Town of Washington Inland Wetlands Commission

PERMIT APPLICATION

Regulated activity: SEPTIC SYSTEM REPLACEMENT

RE: Review of Engineering Plan for Subsurface Sewage Disposal System located at:
210 West Shore Road - Washington

SEPTIC SYSTEM REPLACEMENT PLAN		
EXISTING HOUSE		
210 WEST SHORE ROAD WASHINGTON, CONNECTICUT		
DATE: 12-1-2020	BRIAN E. NEFF LICENSED ENGINEER 128 BACON ROAD ROXBURY, CT 06783 (860) 334-2246	DRAWN BY: B.E. NEFF
REVISED:		DRAWING NUMBER: SHEET 1 OF 1

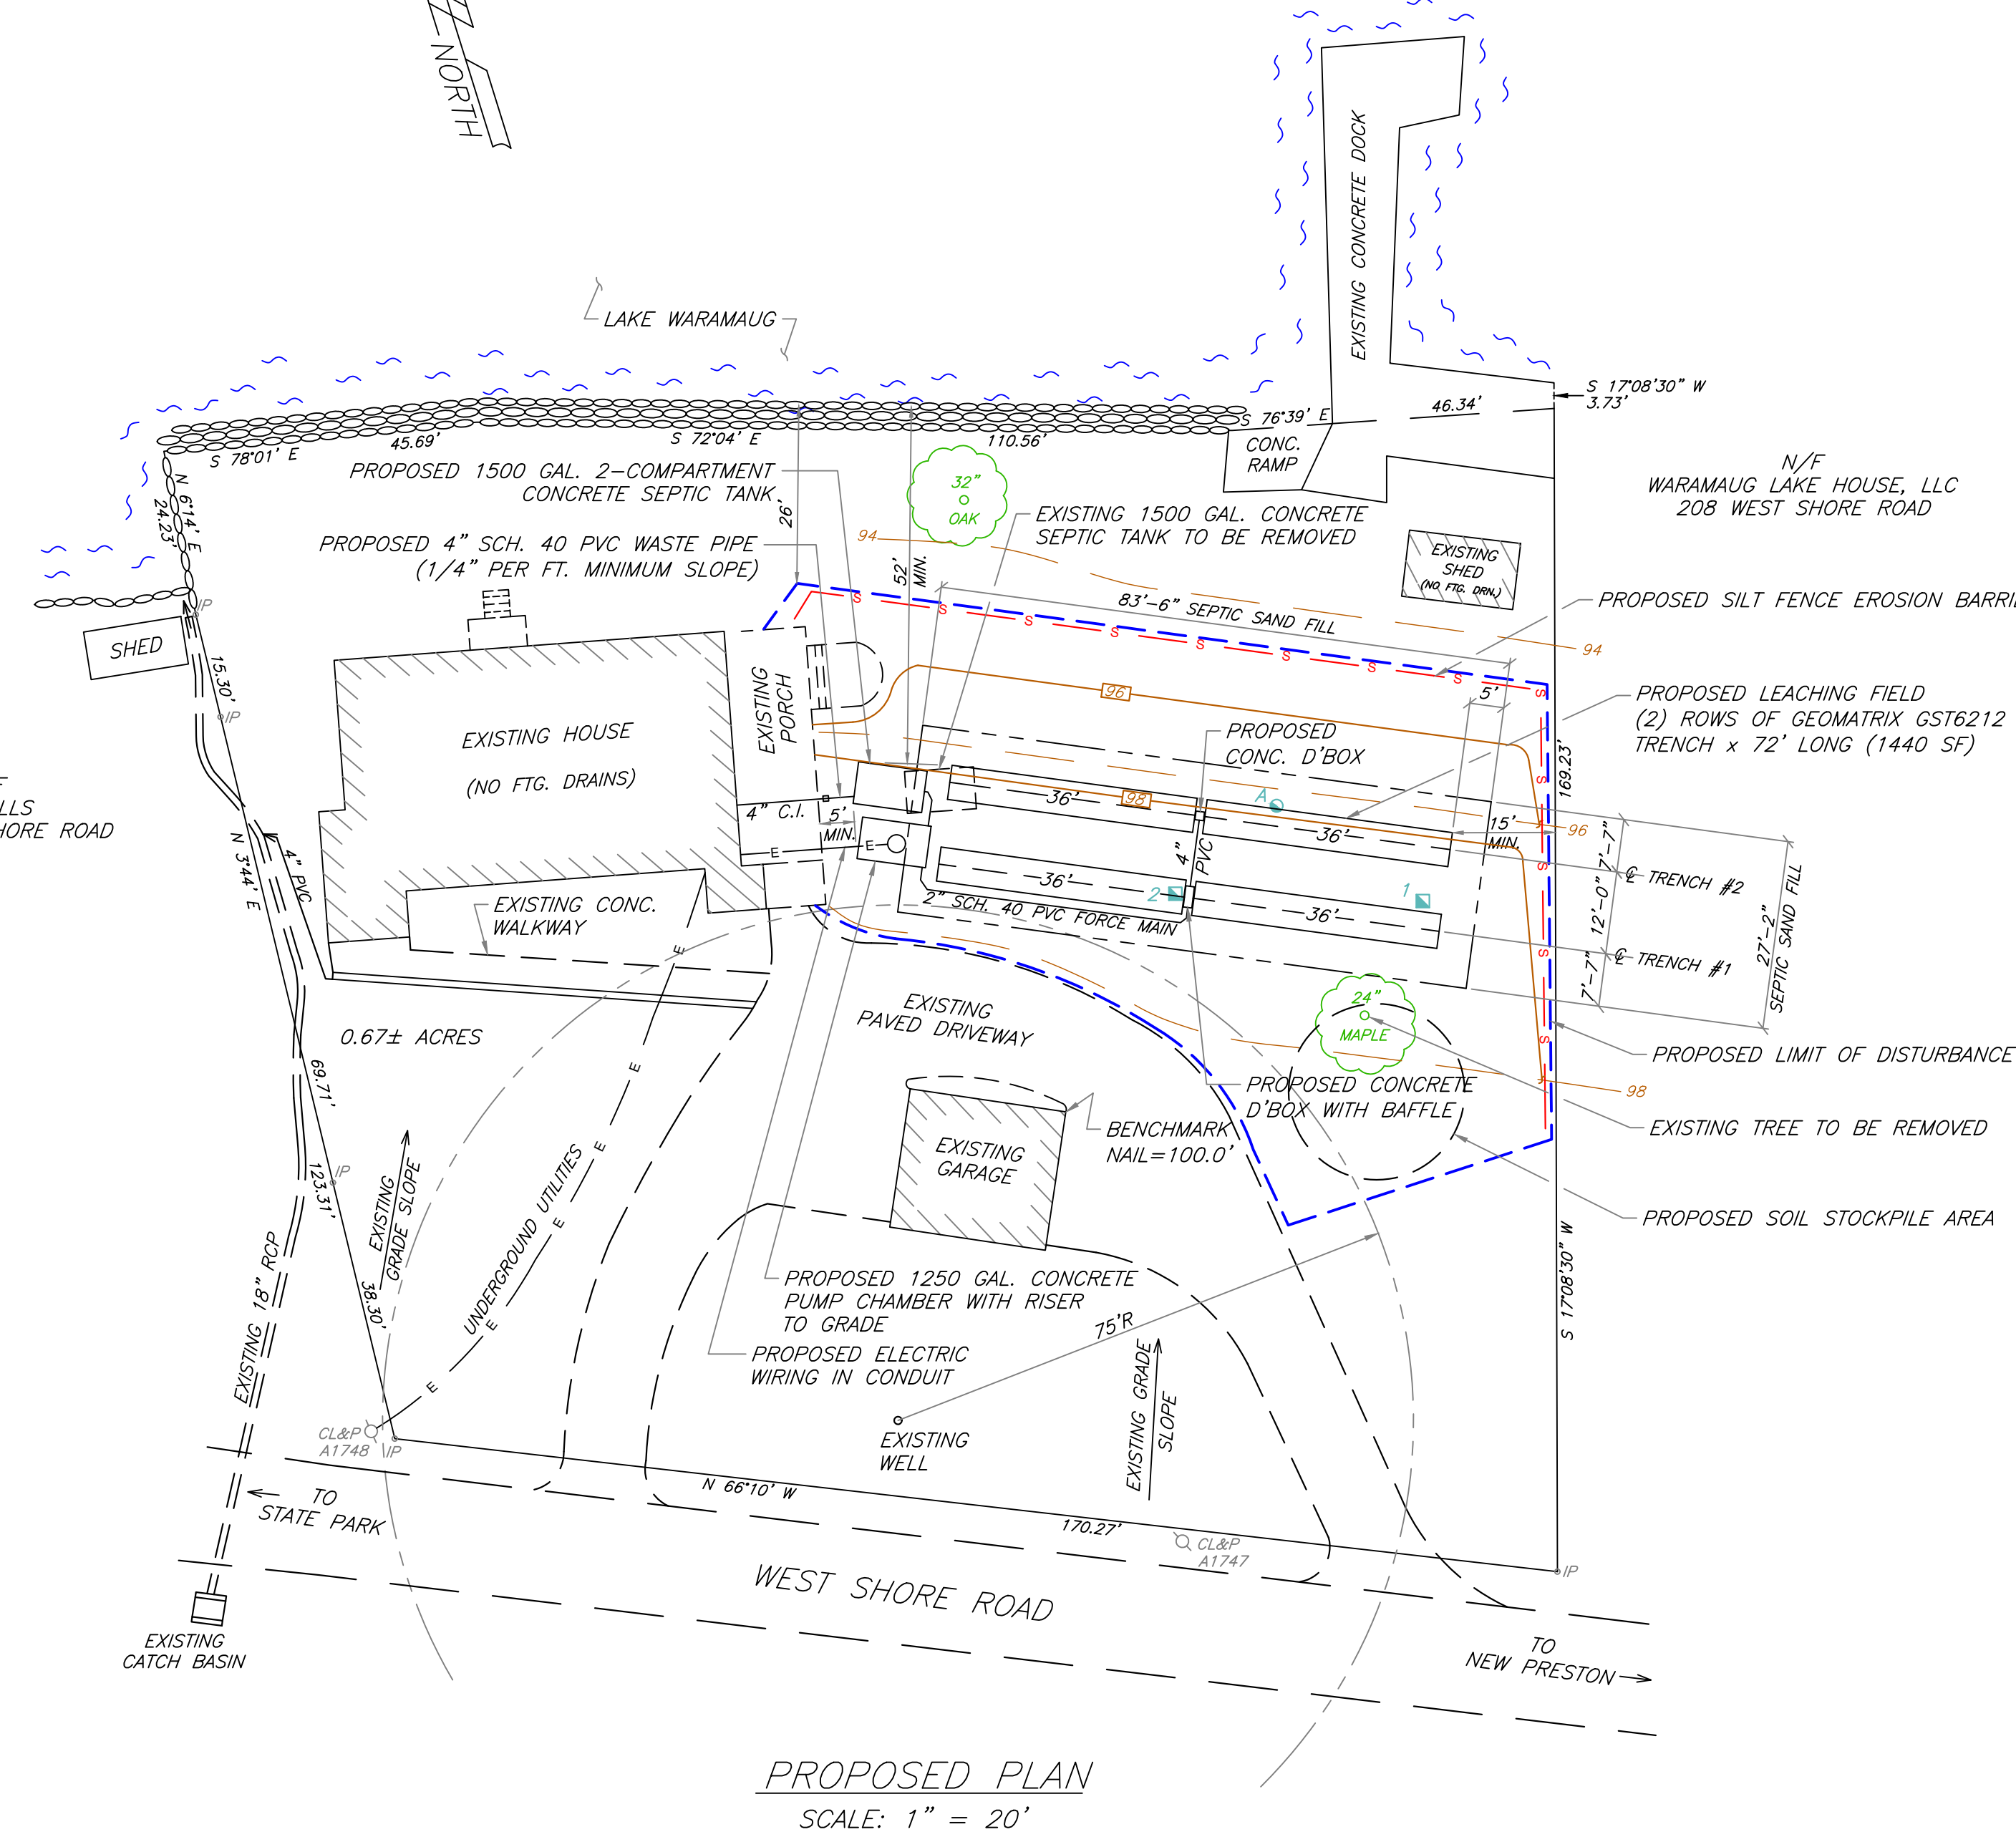
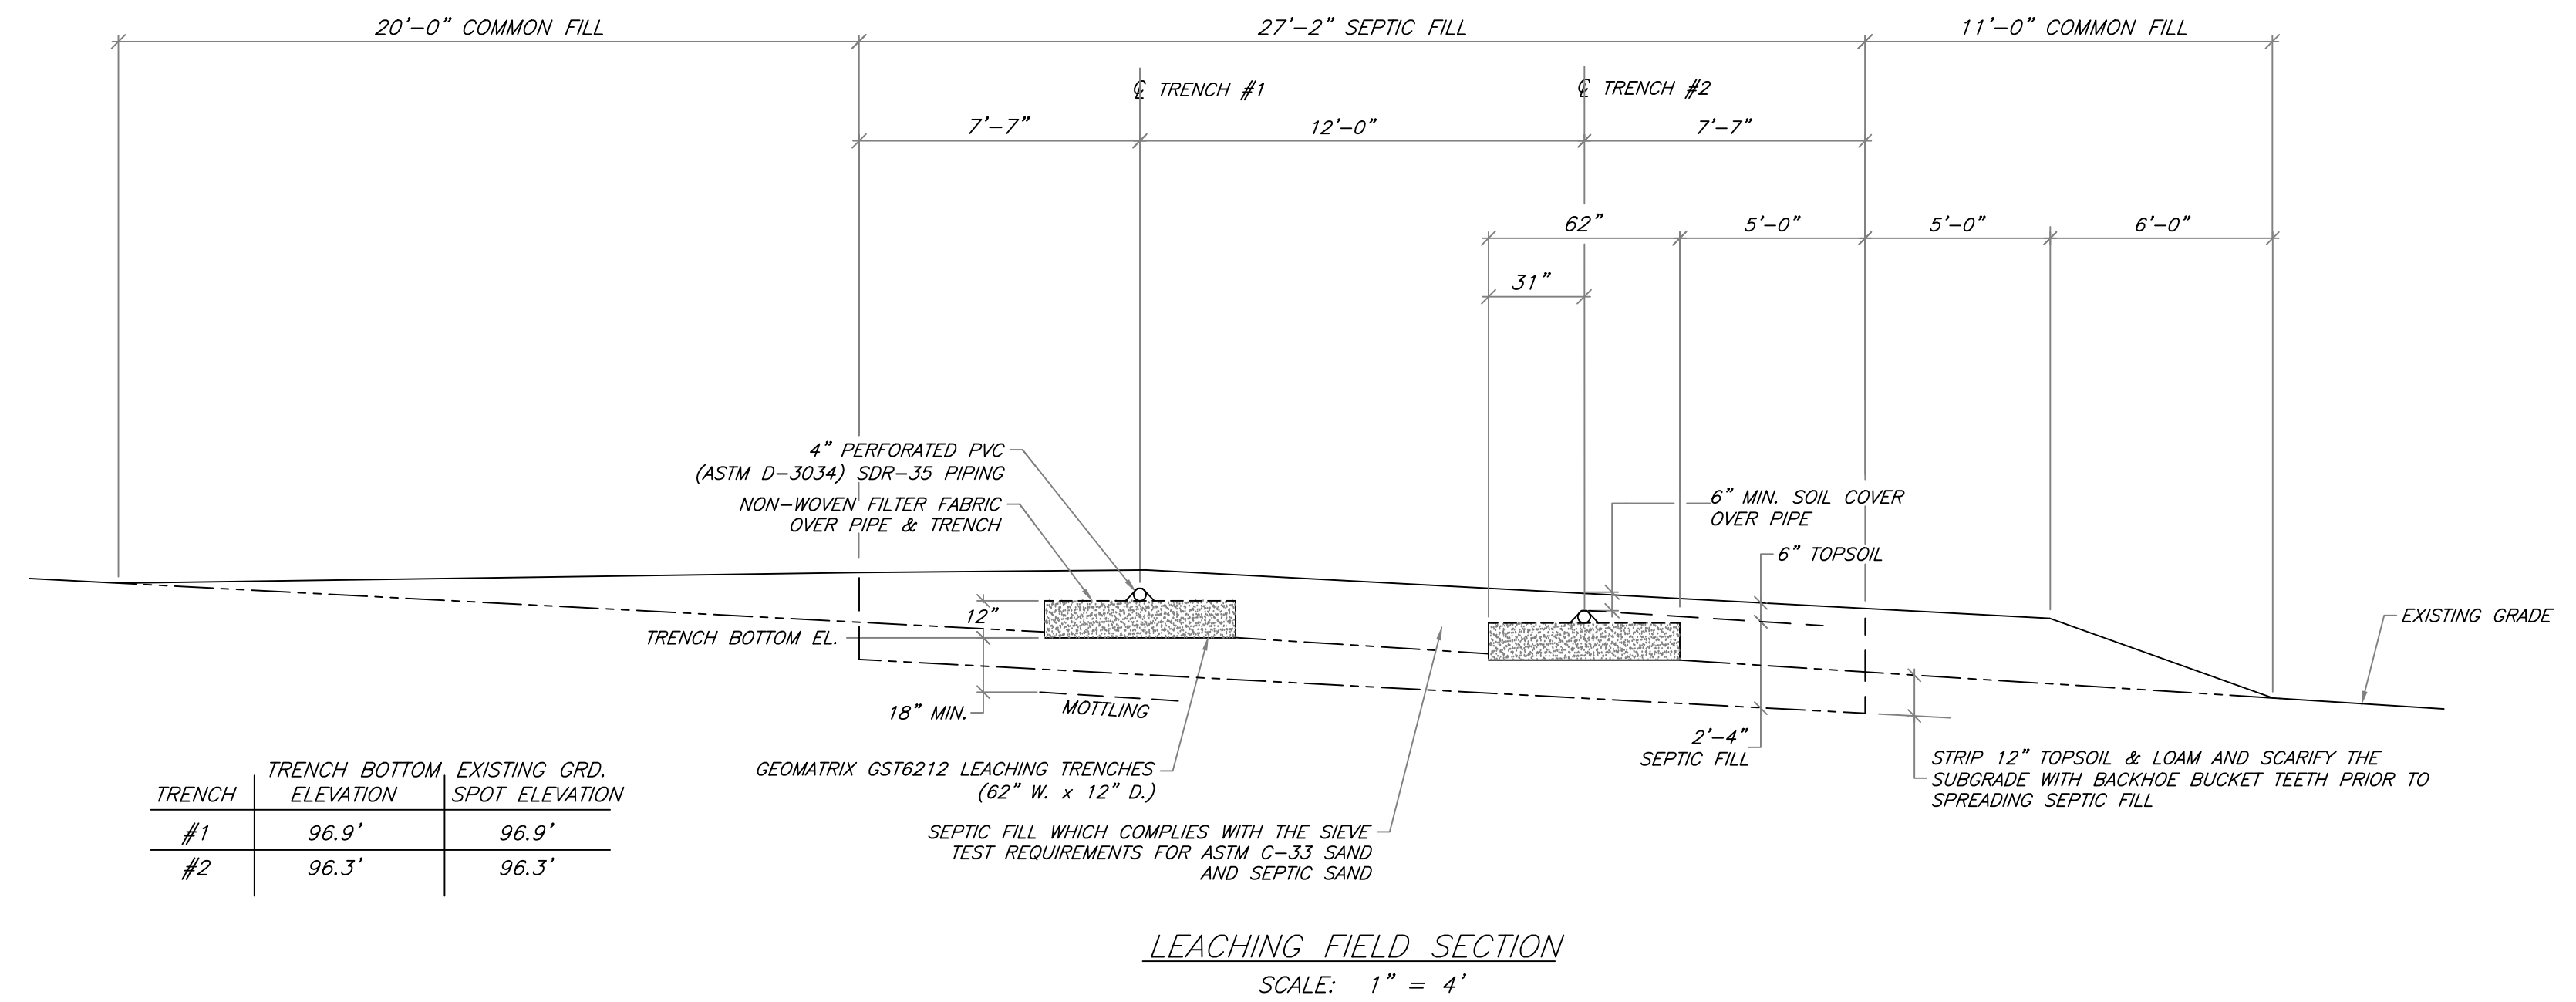
This system does not provide for water softener discharges OR kitchen garbage grinders.
1. Engineer to stake all components of the septic system prior to construction. 2. Engineer to approve quantity, quality and placement of select fill. 3. a percolation test is required in the fill package along with a submittal of the sieve analysis. 4. Engineer to submit an as-built to the Health Department.
